Report to the Future Melbourne (Planning) Committee

**Planning Permit Application: TP-2018-493
84-88 Leveson Street, North Melbourne**

4 December 2018

DELEGATE REPORT

TITLE: GENERAL PLANS - LEVEL 2
 PROJECT: 84-88 LEVESON ST, NORTH MELBOURNE

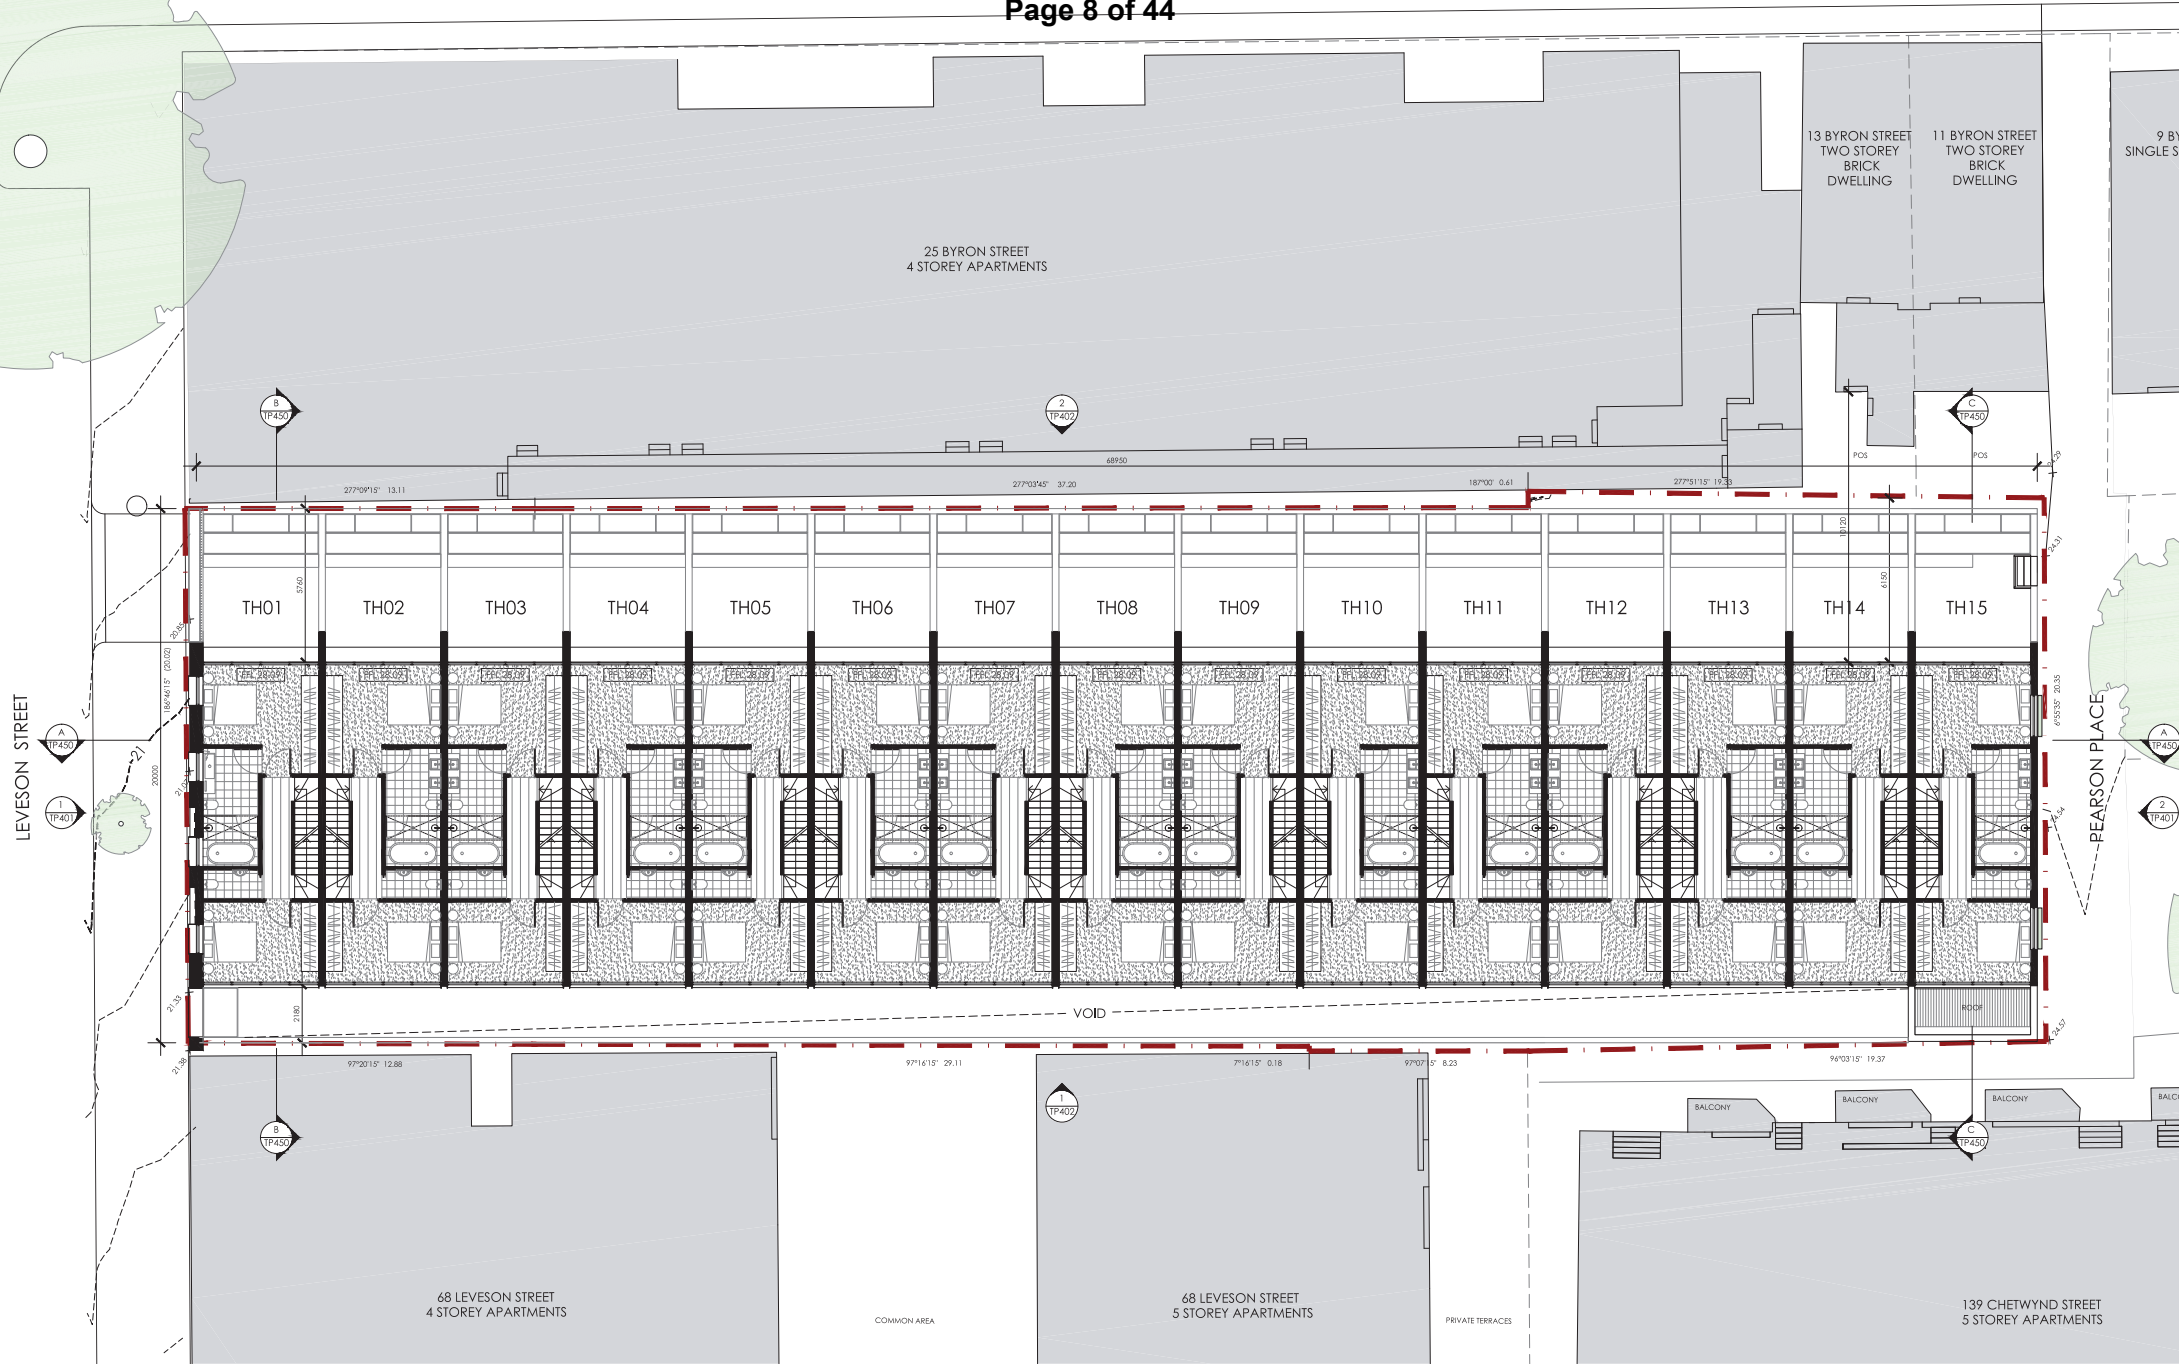
- An 800mm high privacy screen on top of the planter to the first floor balcony to Townhouse 15.
- Deletion of the second and third floor habitable room windows on the east elevation as shown on TP102 Revision C and TP103 Revision C both dated 14 September 2018.

- d) An 800mm high privacy screen on top of the planter to the first floor balcony to Townhouse 15.
 - e) Deletion of the second and third floor habitable room windows on the east elevation as shown on TP102 Revision C and TP103 Revision C both dated 14 September 2018.

TITLE	GENERAL PLANS - LEVEL 3
PROJECT	84-88 LEVESON ST, NORTH MELBOURNE

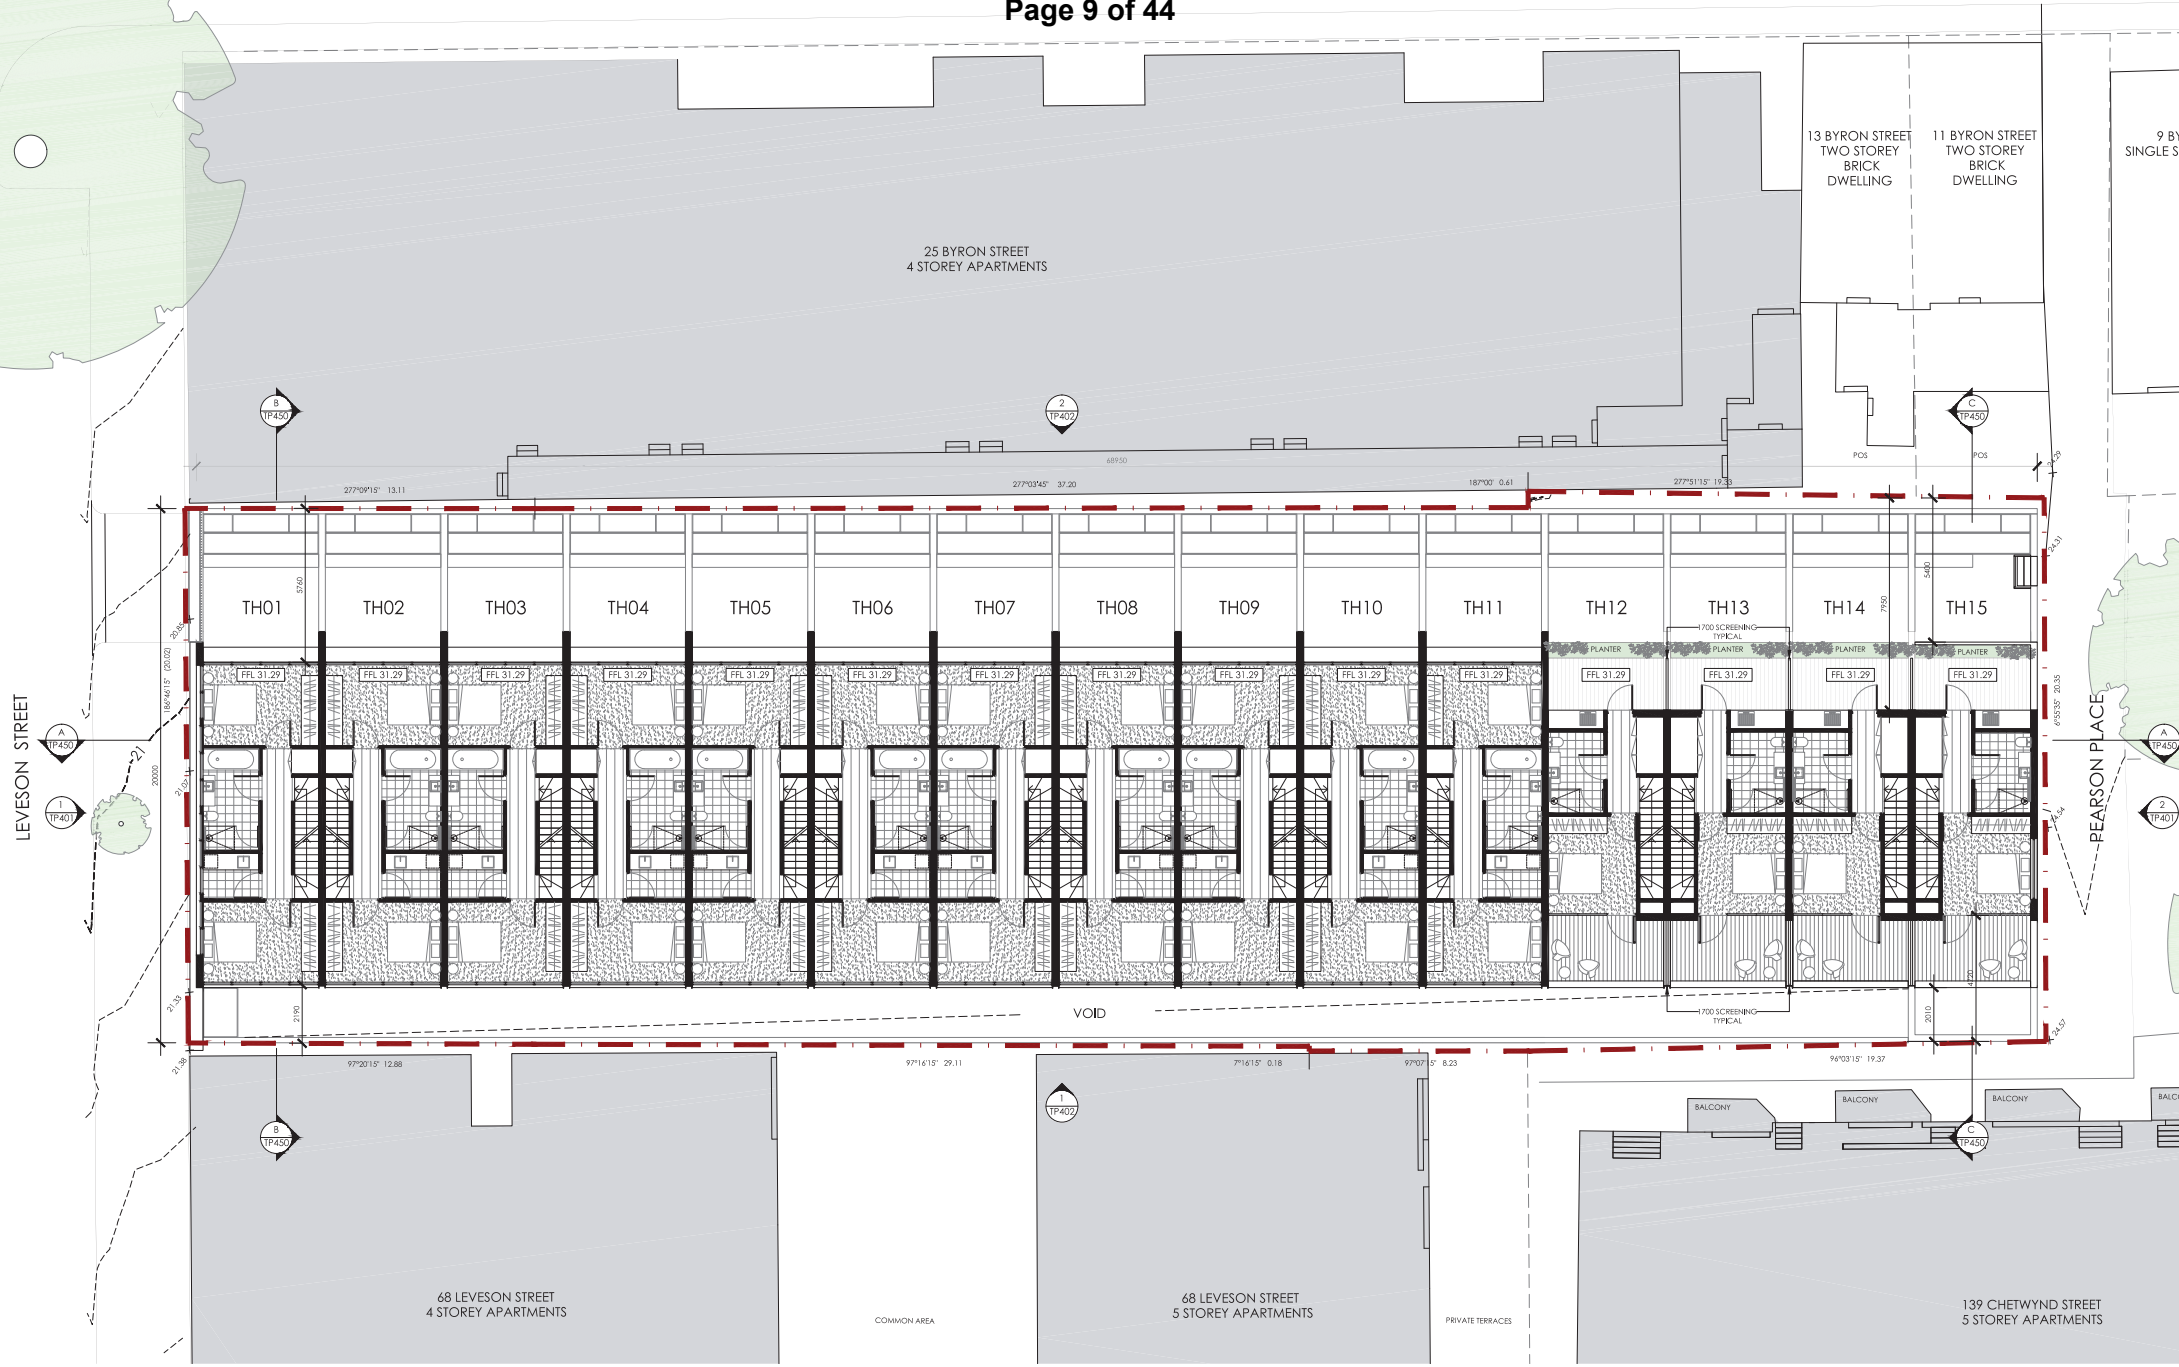
- 1.7m high privacy screens on the east side of the third floor balconies to Townhouse 15 as shown on TP-103 Revision C dated 14 September 2018.
- The second and third floor habitable room windows on the south elevation of Townhouses 5, 6 and 7 to have fixed obscure glazing to 1.7m high as shown on TP102 Revision C and TP103 Revision C both dated 14 September 2018.

GROUND LEVEL | OPTION A (3+3 660L BINS)
LEVESON STREET, NORTH MELBOURNE

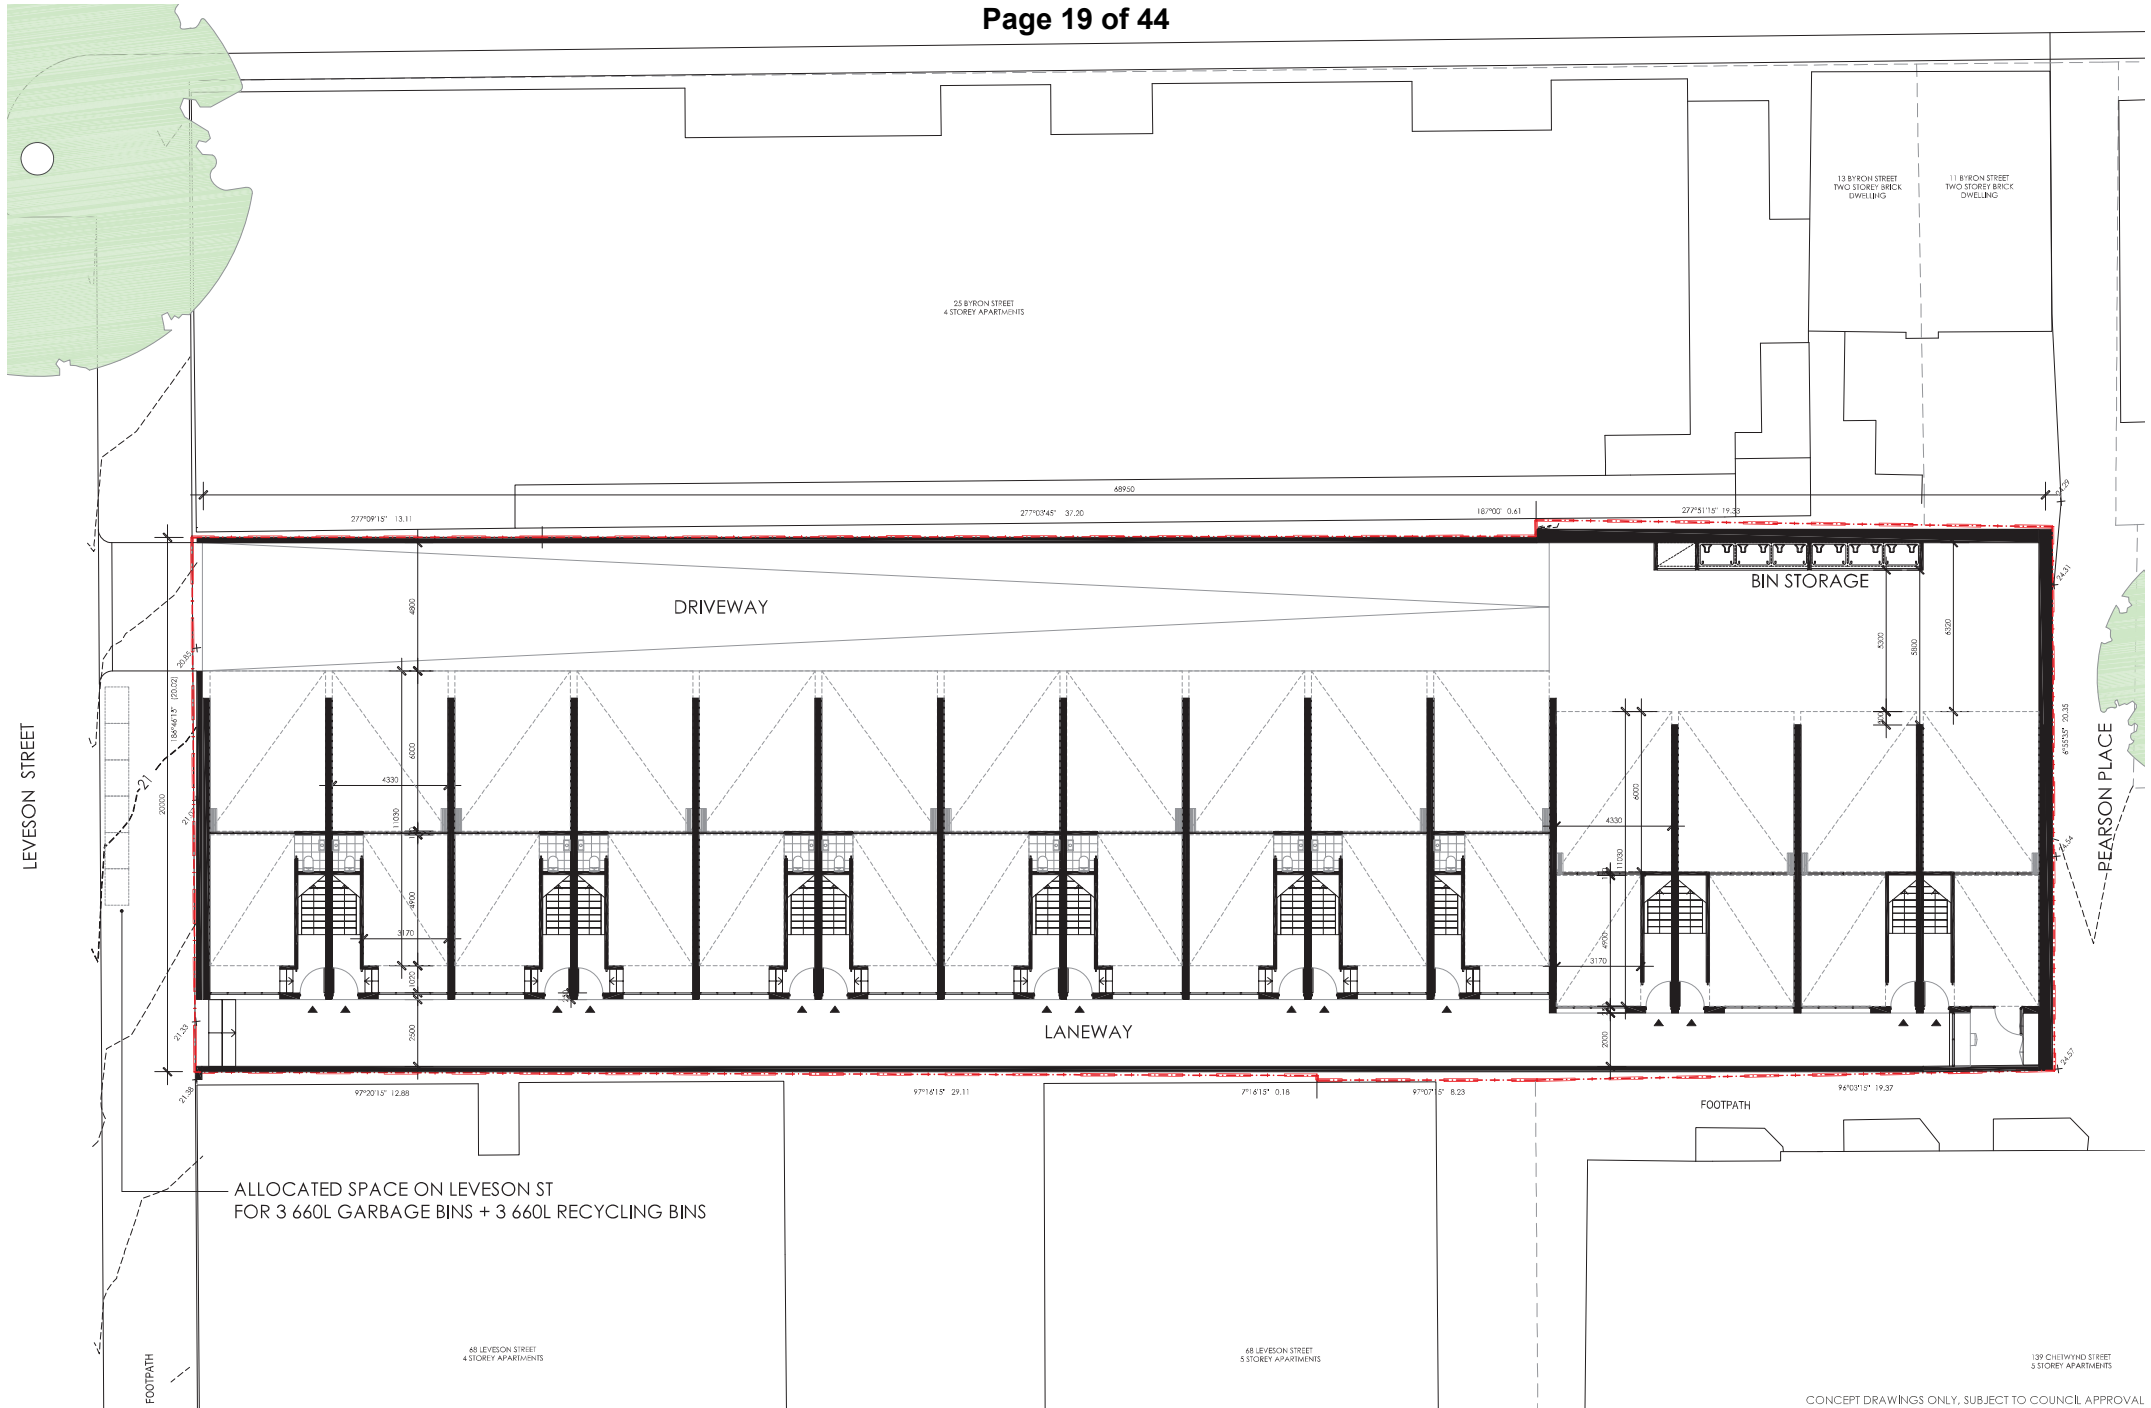
A revised Waste Management Plan by Leigh Design Pty Ltd dated 21 September 2018 was received 23 September 2018, which included a communal bin store in response to Engineering Services' referral comments.

- a) A communal bin store as shown on the revised Waste Management Plan by Leigh Design Pty Ltd dated 21 September 2018.
 - b) Updated swept path diagrams to demonstrate that vehicles can enter and exit the site in a forward direction.

Sightline diagram

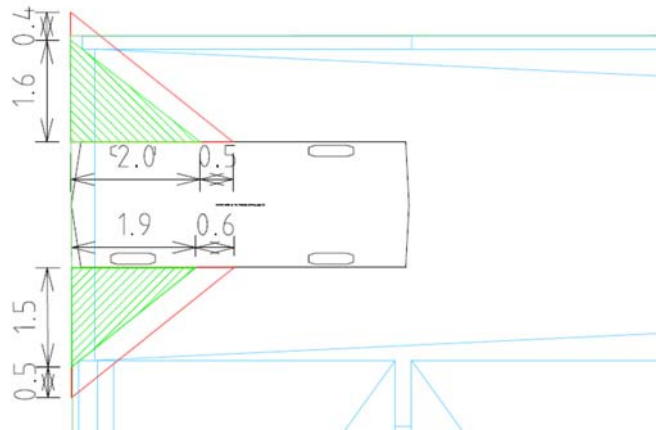
Engineering Services requested that pedestrian sightlines be provided in accordance with the Melbourne Planning Scheme.

Clause 52.06 requires accessways to have a corner splay or area at least 50% clear of visual obstructions extending at least 2m along the road frontage and 2.5m along the exit lane to provide a clear view of pedestrians.

The sightline diagram demonstrates that more than 50% of the pedestrian sightlines will be clear of visual obstructions; as such the design standard is met.
